To: Samantha Crowder

From: Chris LaRue, Senior Planner

Date: February 10, 2021

Re: PUDA- 01184-2020, Bridgewater PUD Amendment No. 6

BRIDGEWATER P.U.D. OVERLAY MAP – AMENDMENT NO. 6

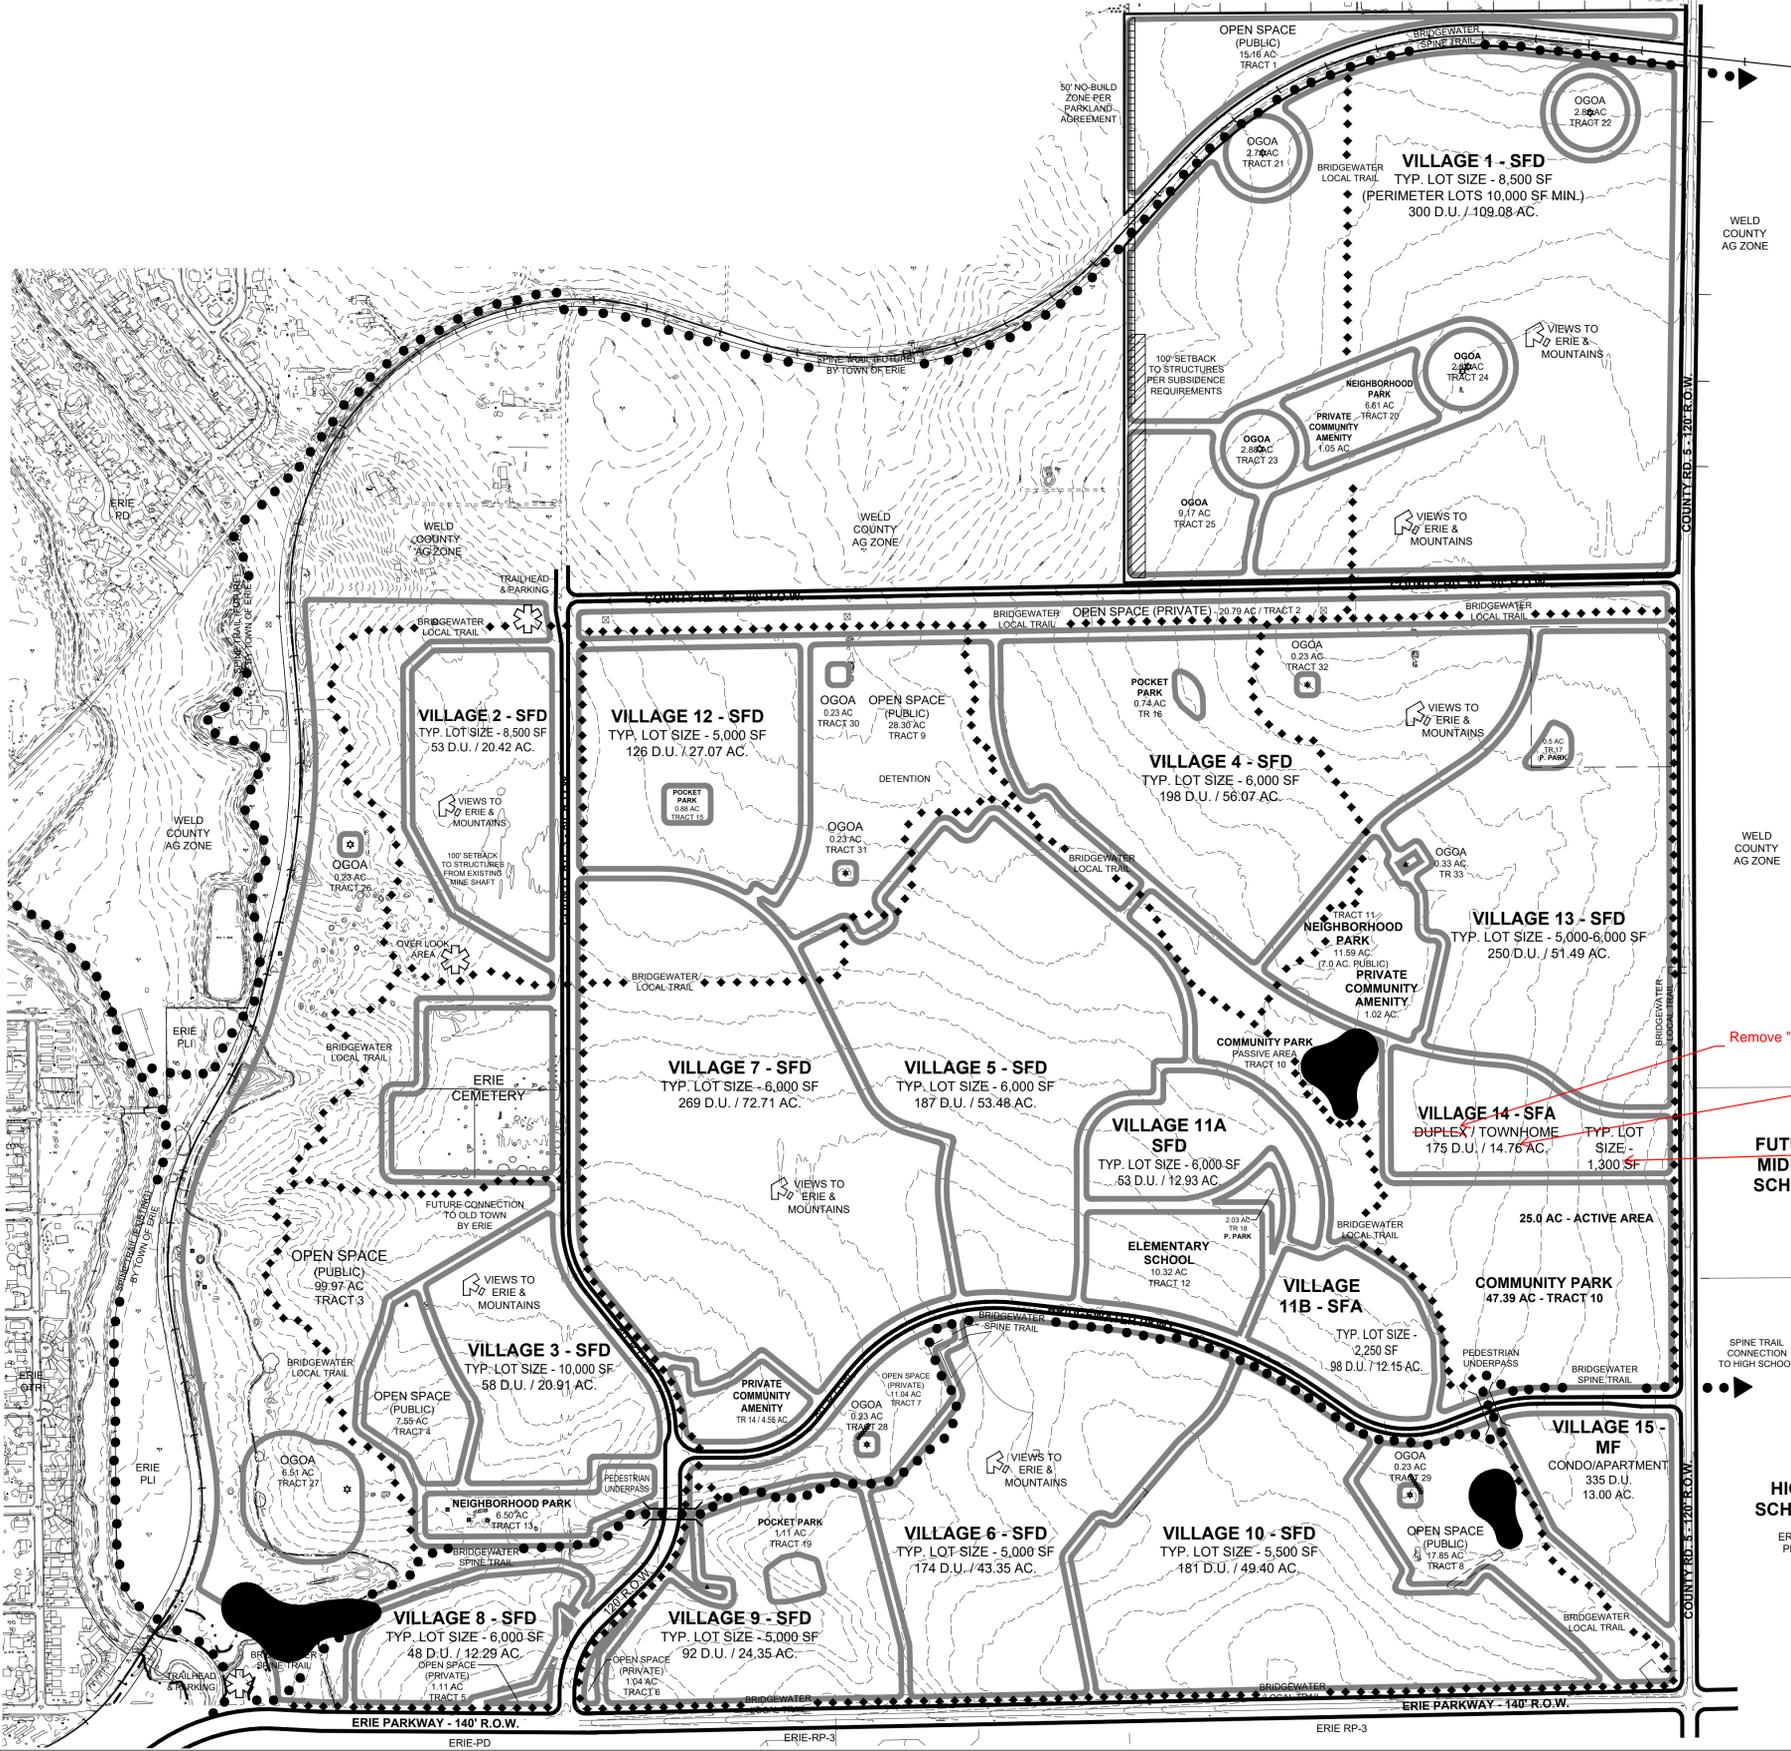
Could we replace "Bridgewater" with "Colliers Hill"?

TYPICAL SINGLE-FAMILY LOT SIDE SETBACK CONDITIONS
(ENCROACHMENTS ALLOWED IN SETBACKS)

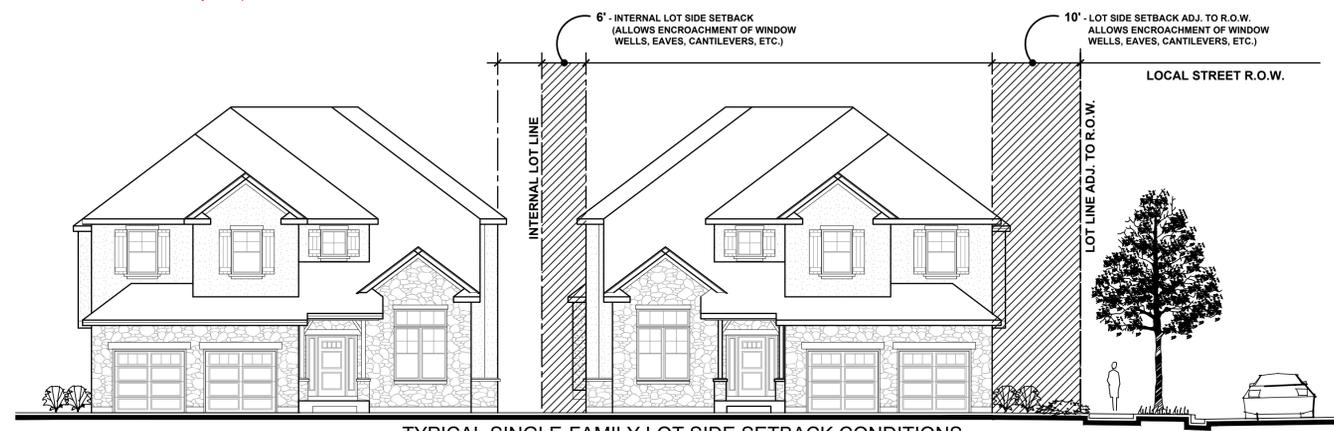
Not sure where the front is? Wouldn't the landscape common area be a 0' setback with encroachments? Is the alley the front setback? An exhibit should be included within the PUD depicting the setbacks. See "Erie Highlands PUD Zoning Map Amendment No. 2" where a "definitions" key was provided.

Will the TH products have basements? If not, this shouldn't be applicable to the TH area.

EXHIBIT 1.1

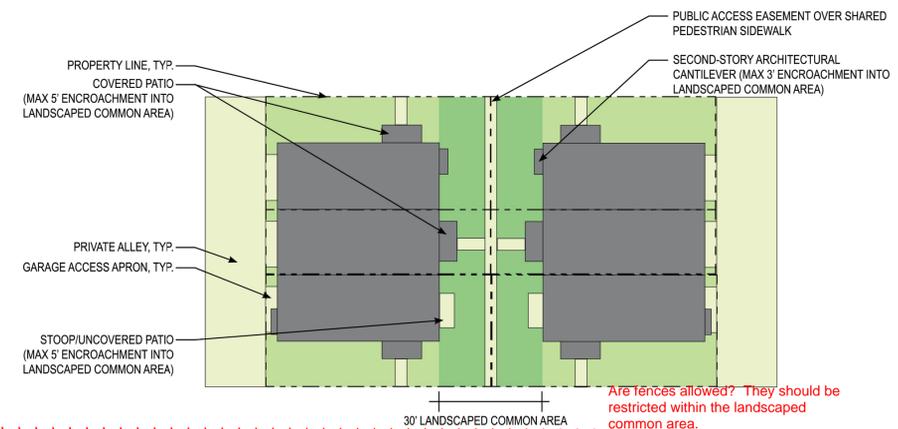
How are the end units which face each other dealt with in terms of what their front doors face? See section 10.6.7.F.1.c. Another exhibit may be necessary for this circumstance. See sketch plan.

BRIDGEWATER P.U.D. OVERLAY MAP – AMENDMENT NO. 6

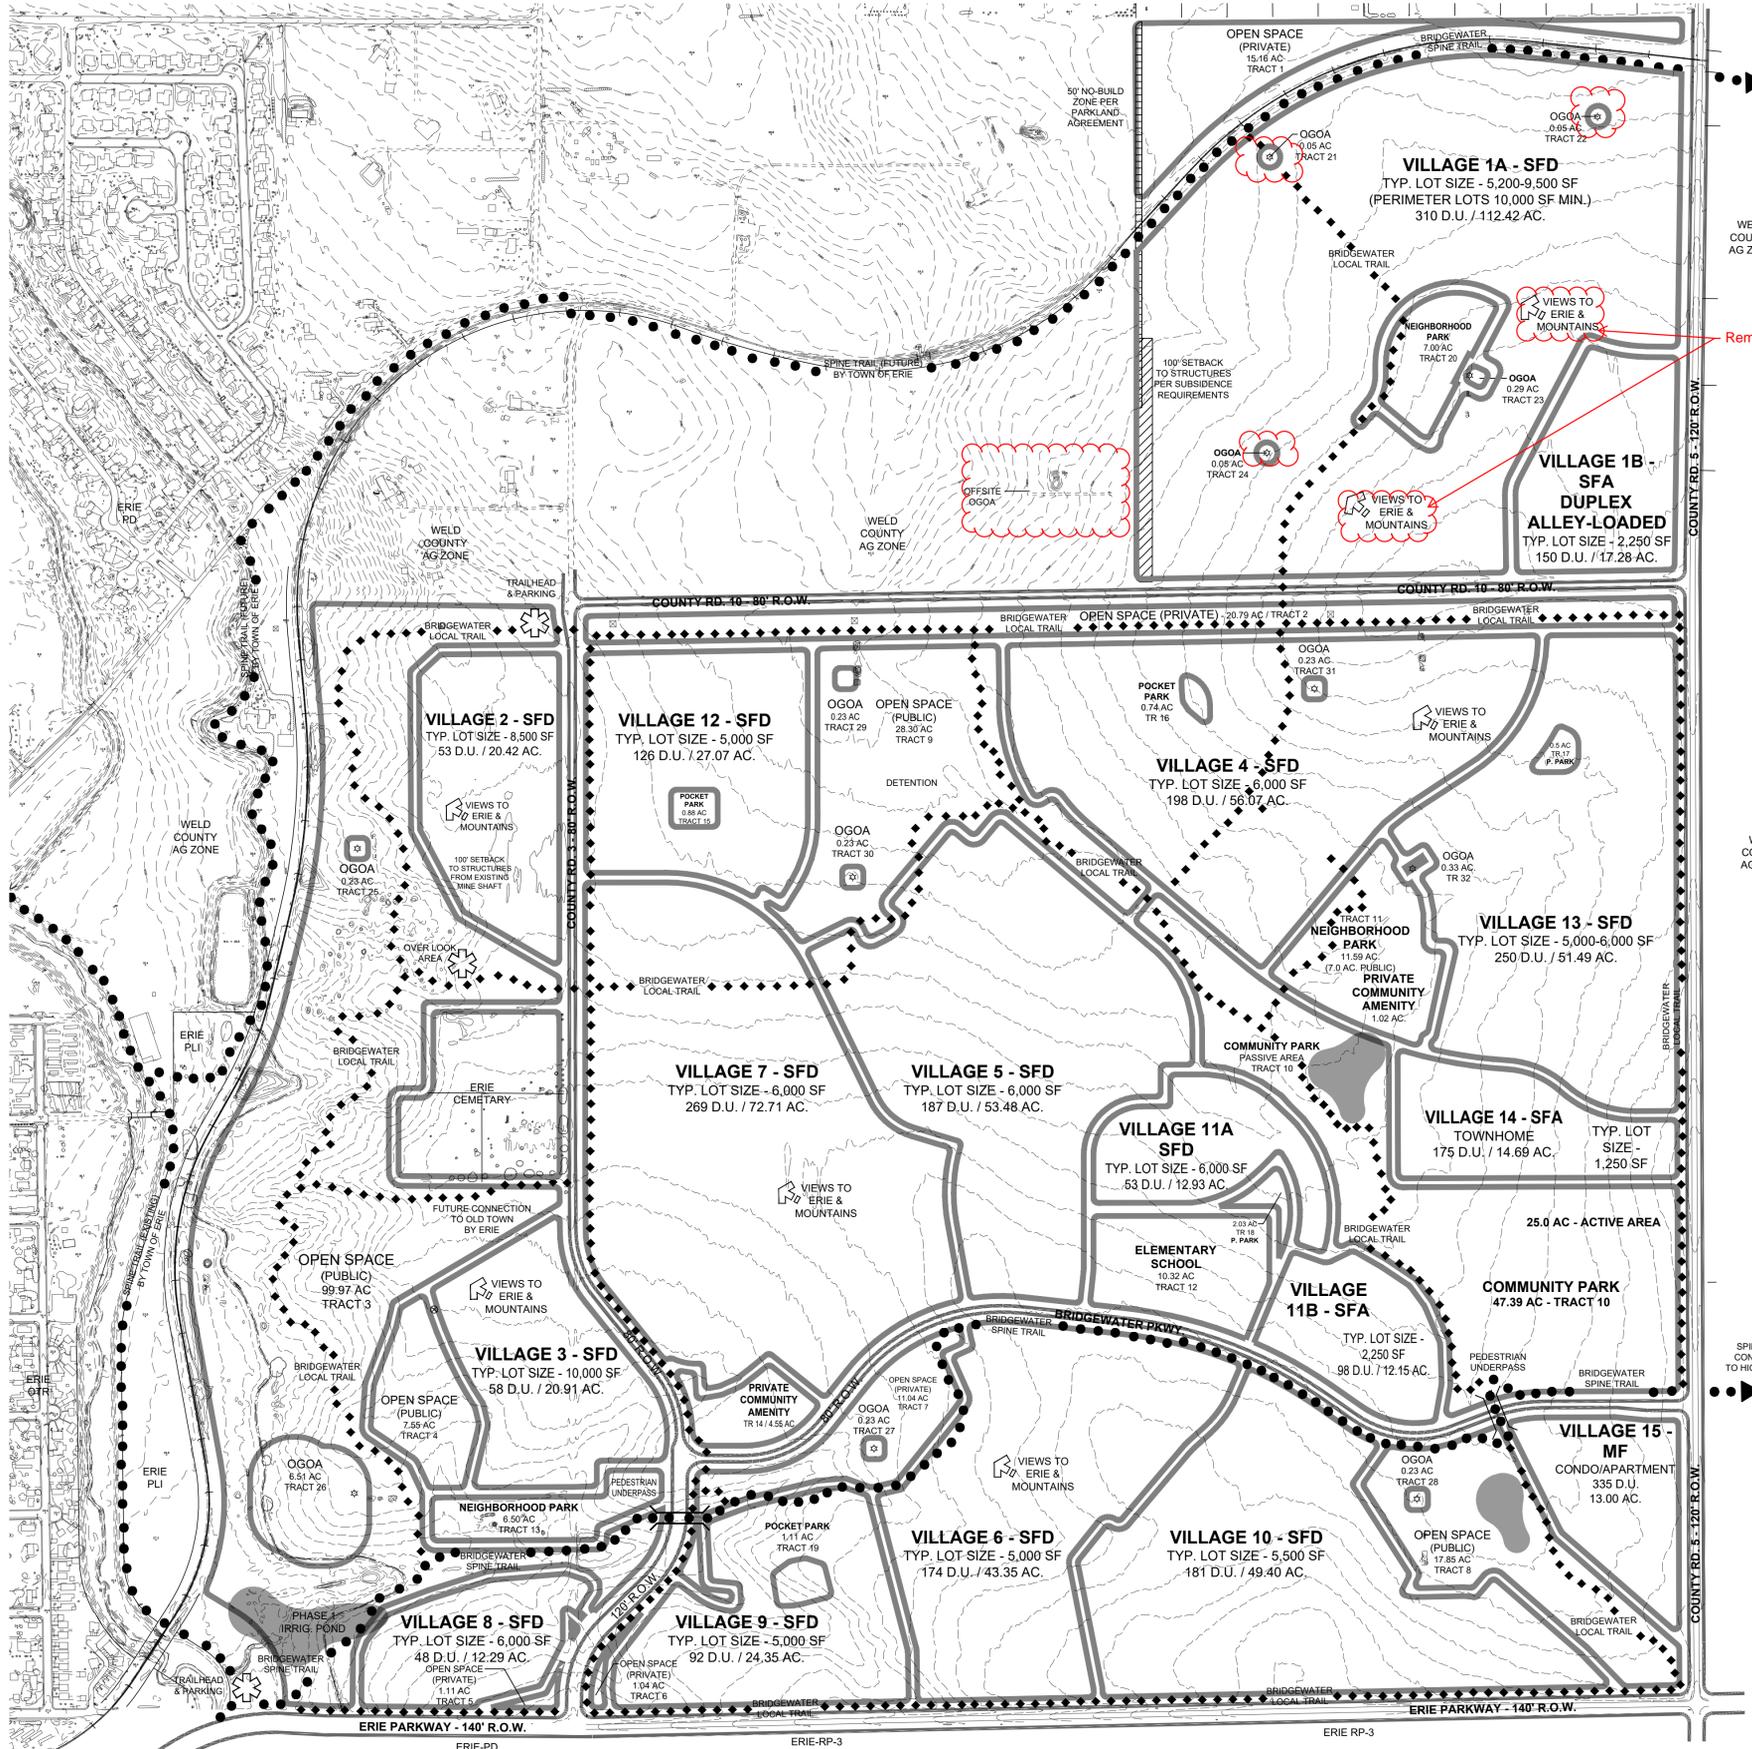
Comment not addressed, though it was stated this was being worked on: Provide an exhibit for the oil and gas impacts. It should depict all the relevant components of the SUAs and the UDC. See comment # 2 on the sketch plan comments, which will require responses with PUD Amendment No. 7.

-Remove O & G info from this area.

-A note/requirement should be added onto the PUD reflecting the O & G setbacks from the UDC. Minimum 350' from active O & G and a minimum of 25' for abandoned O & G facilities.

Applicant Response: Acreages represented in this PUD are reflective of zoning areas and are not a direct comparison to approved acreages represented in Final Plats.

EXHIBIT 1.1

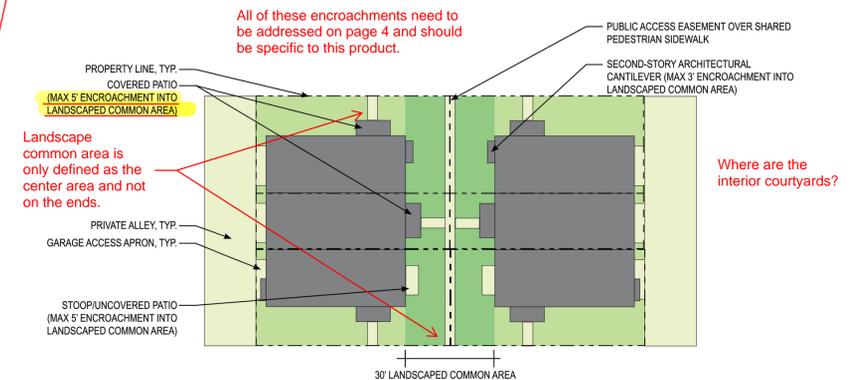
Landscape common area is only defined as the center area and not on the ends.

LR (SFA - TOWNHOME-ALLEY LOADED) - SETBACK EXHIBIT, TYPICAL

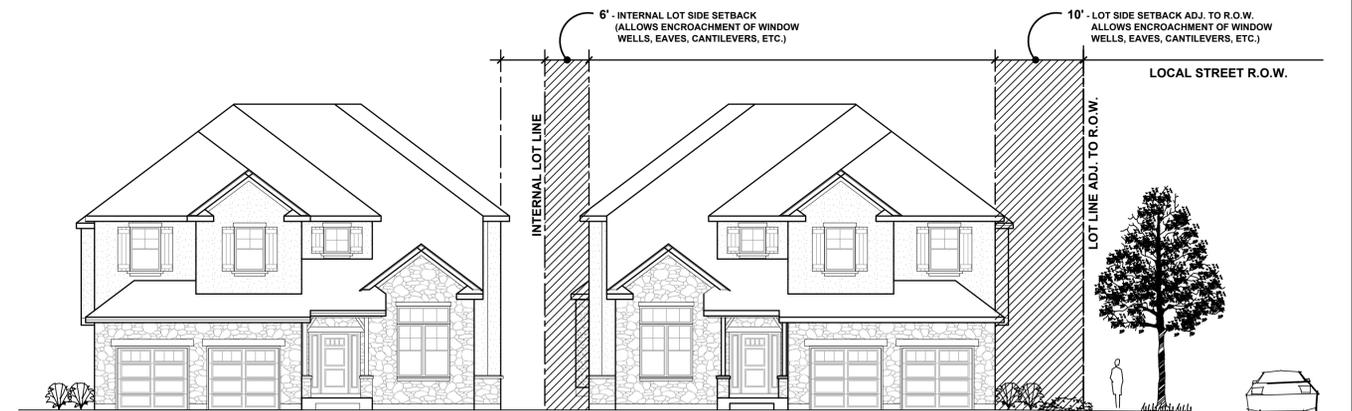
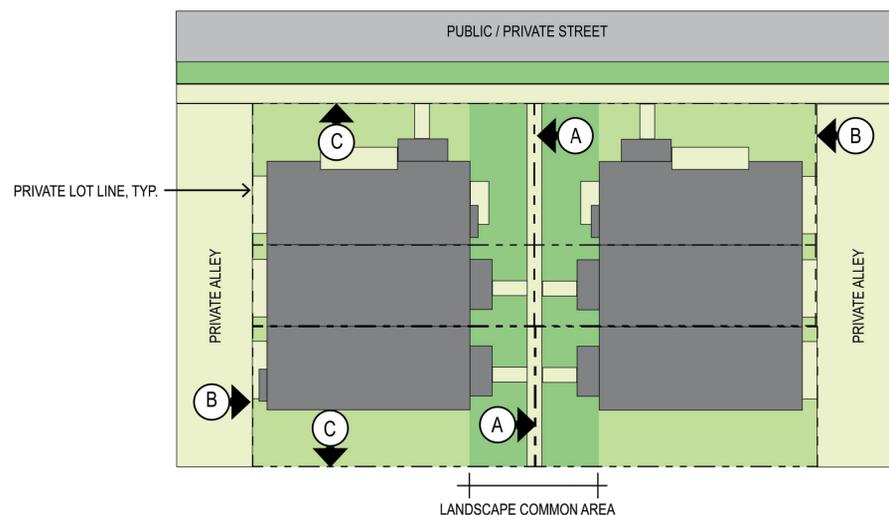
Not sure about this "OS" reference. Delete it since it also includes "Common Landscape Areas".

EXHIBIT 1.1

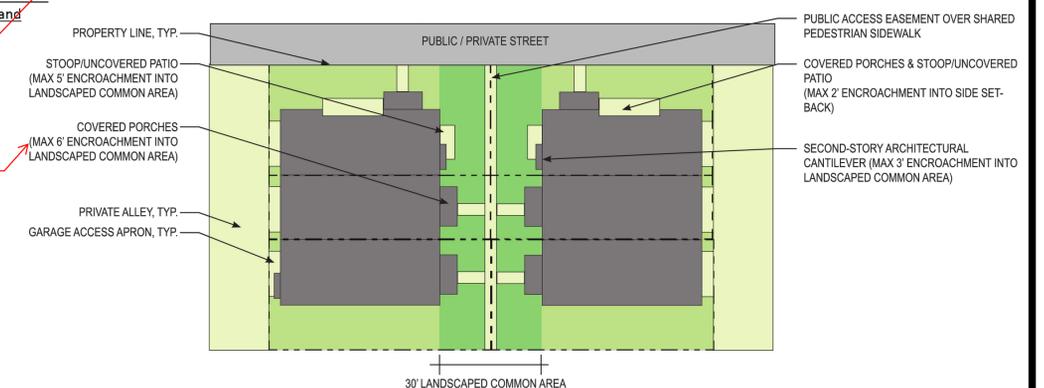
6' looks like a typo? Previously it stated 5'. Also it states 5' in the front porch section.
